# Addendum 1

March 20, 2020

## **Tender T20-11 Greenwood Trunk Sewers – Addendum No. 1**

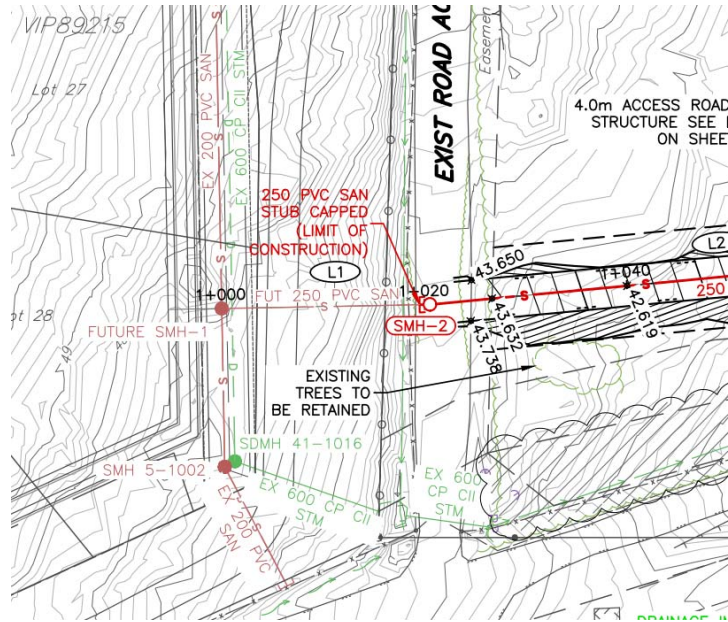
5. The limit of construction for the project is noted to be the 250 PVC Cap at station 1+019.511. The main shown as future and Future SMH 1 shown on the below sketch is not included in the works.
